Preliminary Subdivision Comments

Plan: Healey Corner
195 Tahattawan Rd

Date Submitted: October 26, 2018

Attached: One page map indicating publicly accessible permanently protected open space/ conservation land abutting and contiguous to Glavey Family Trust Land

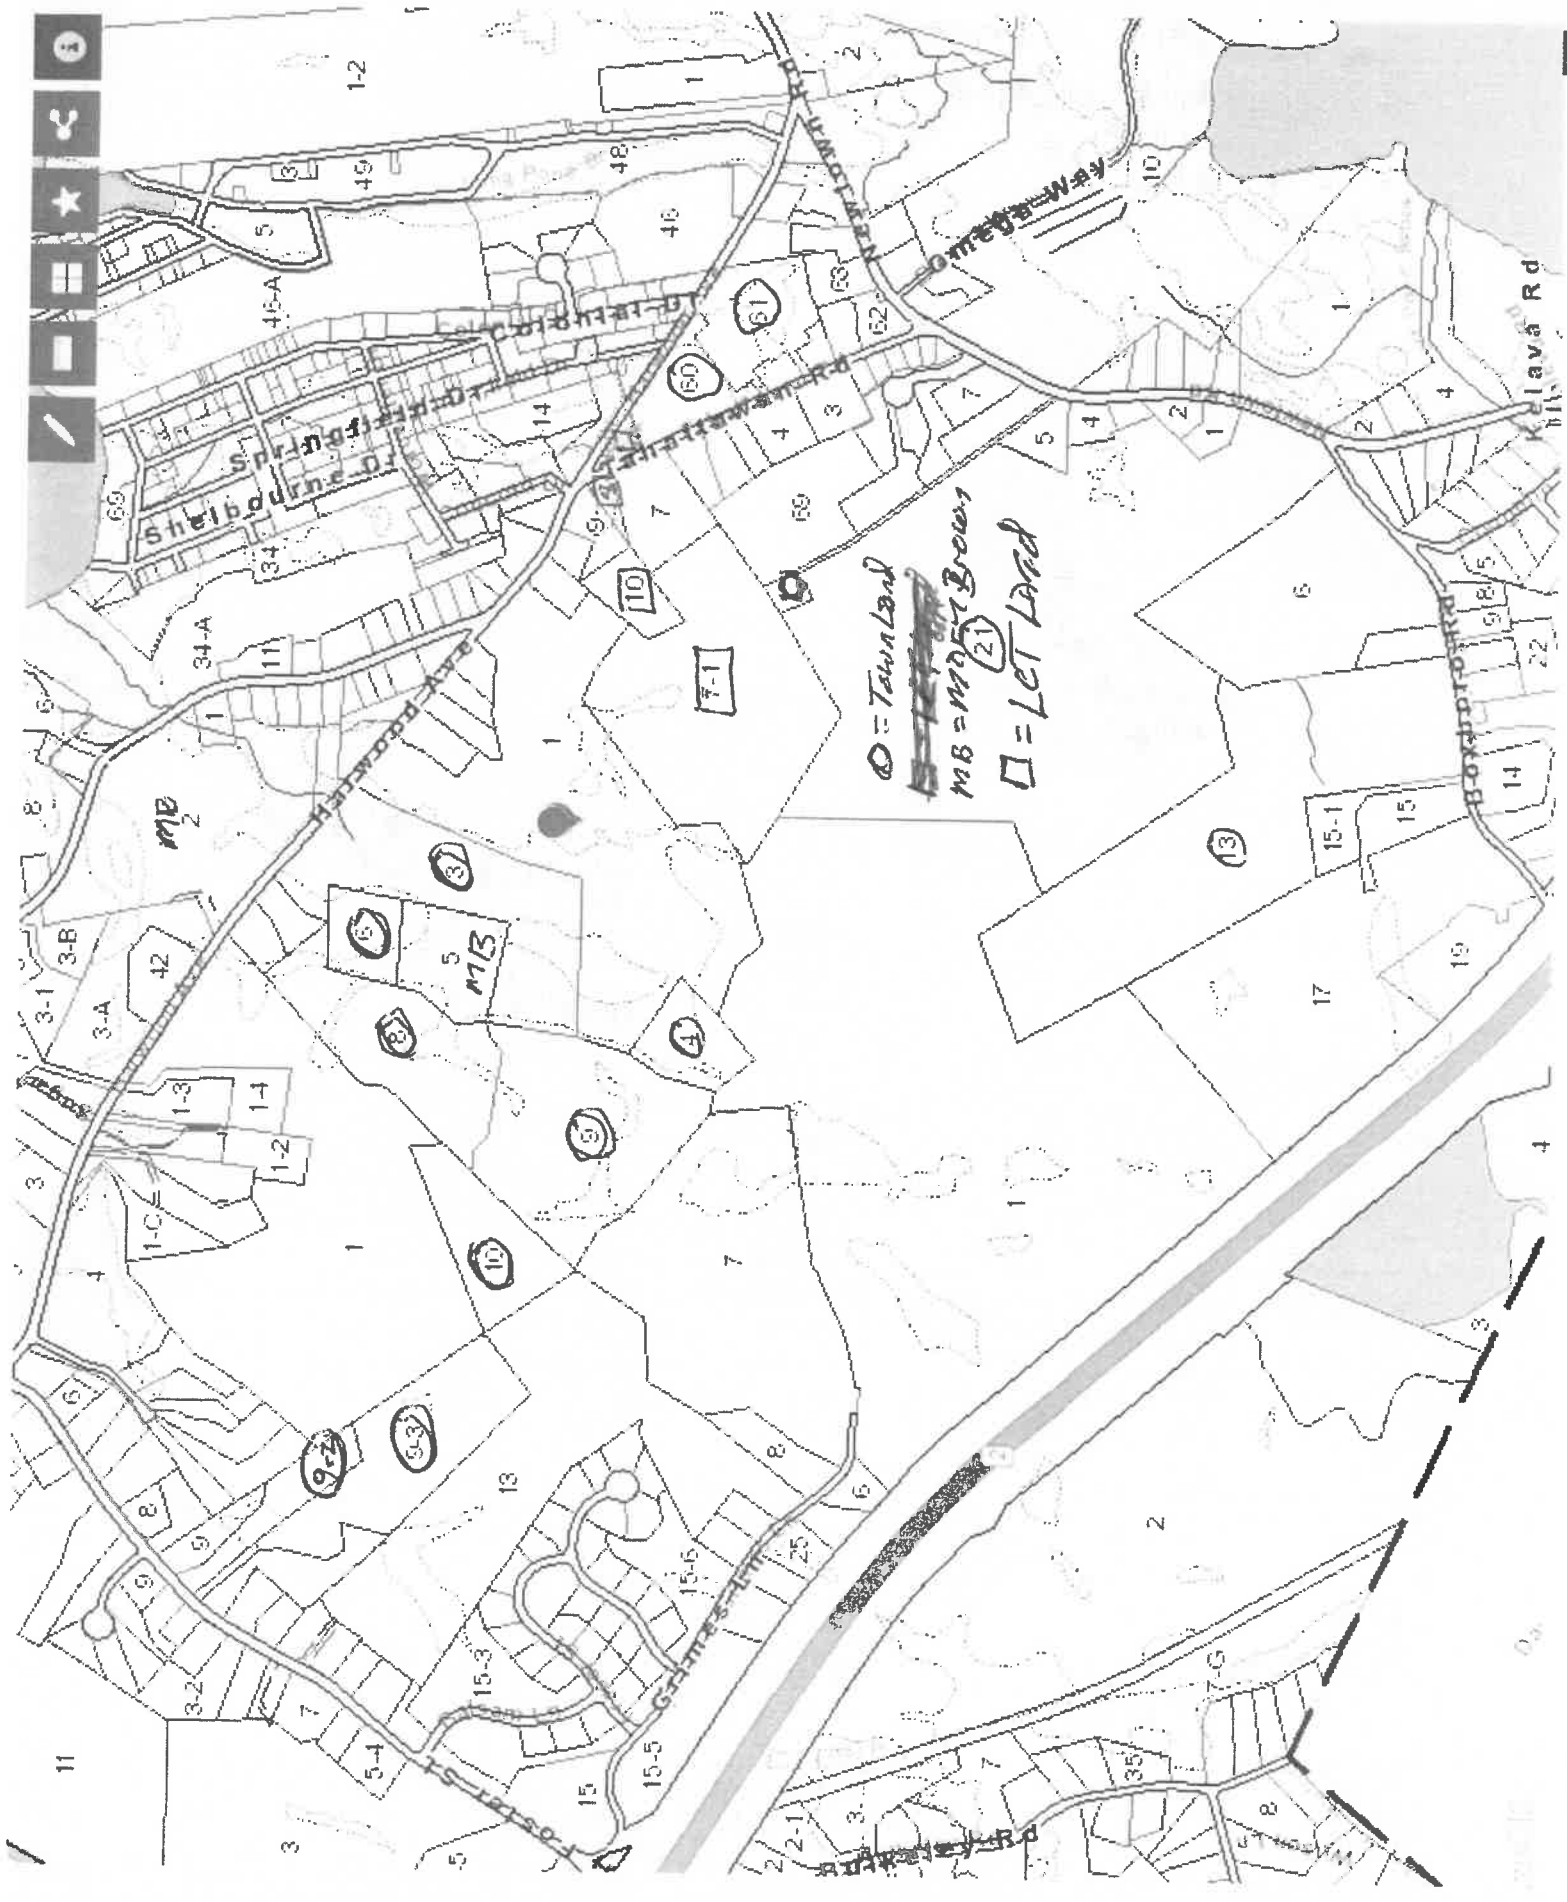
The 43 acre Glavey Family Trust land separates some 8 publicly accessible abutting/contiguous town owned land parcels on the northwest side (toward the Town Forest and Foster Street) from some 9 publicly accessible abutting/contiguous town and conservation trust lands on the southeast side (toward Newtown Hill Area). Also two adjacent Mary Brown owned parcels are currently in play not mention other development in the contiguous general area

There needs to be some additional planning with open space planning groups (Conservation Commission, Open Space Committee, and Littleton Conservation Trust) that serve the Littleton public, the Family Trust Land Planners, and perhaps a Planning Board Representative to see if a better plan can be generated and see if an interconnected land parcel and/ or greenway can connect these two large permanently protected open space areas. I would suggest a walk over of the areas of concern.
